Al-Muslim Apparels Ltd. (Extension)

East Narsingdipur, Ashulia, Savar, Dhaka.
(23.9245265889, 90.308980602)
13 June 2023

Building Information

Concrete strength for column and foundation considered in DEA report

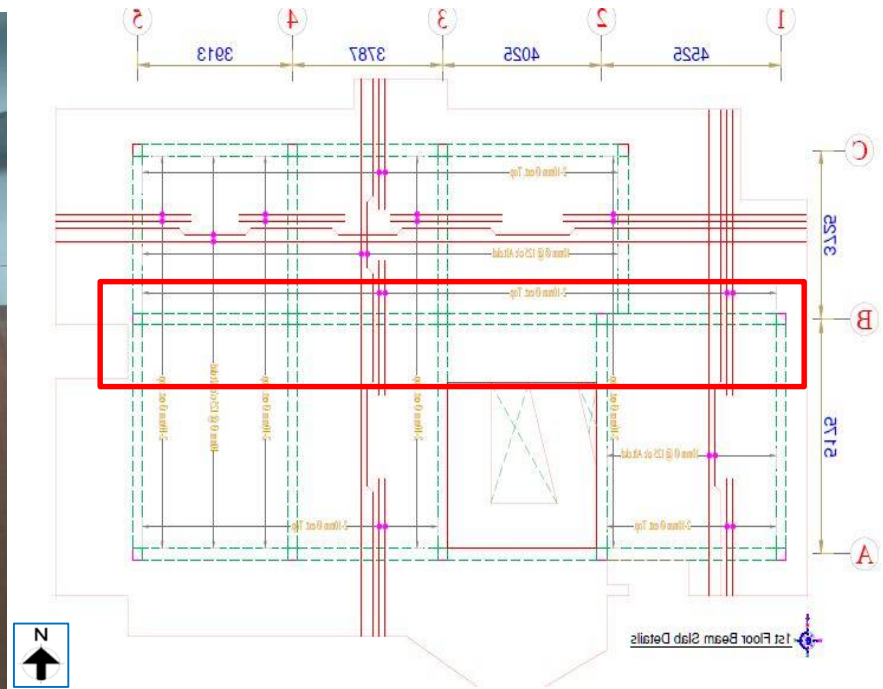
Concrete strength for column and foundation considered in analysis as 20.68 MPa without any test report. Also, rebar strength is considered as 400 MPa but the building was constructed before 2005. Building engineer is required to update the DEA report as per proper material strength of concrete and rebar.

Level difference in roof slab

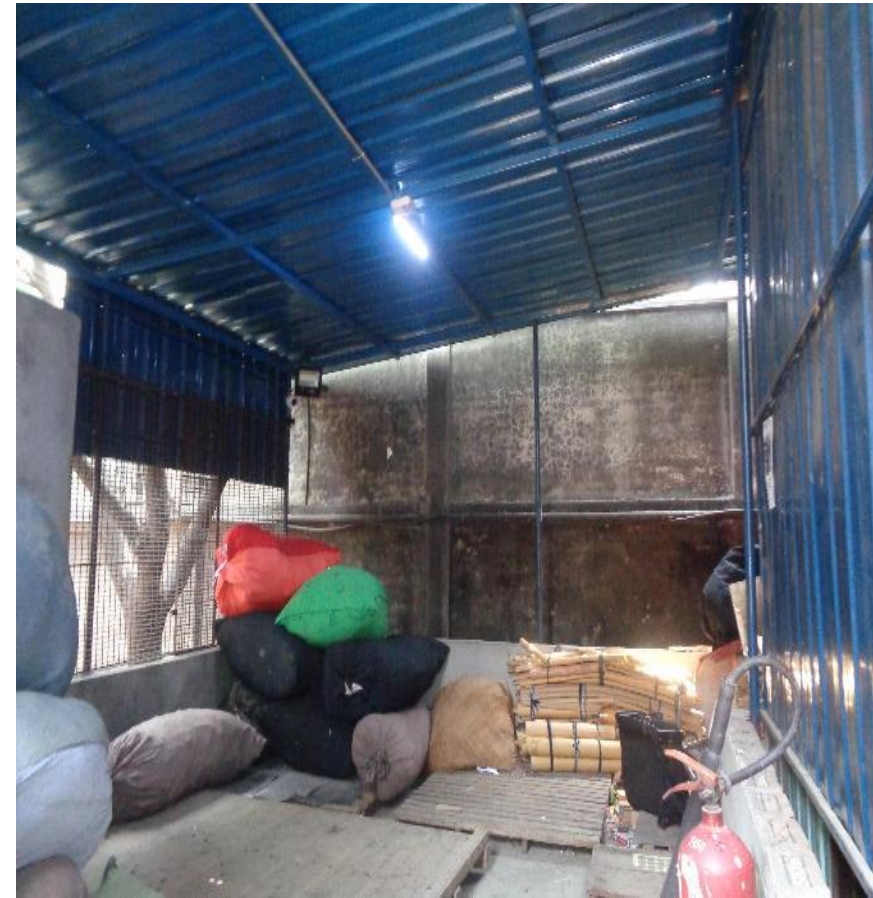
Level difference not shown in slab layout

Level difference in roof slab which was not shown in slab layout. Building engineer is required to update the as-built drawing.
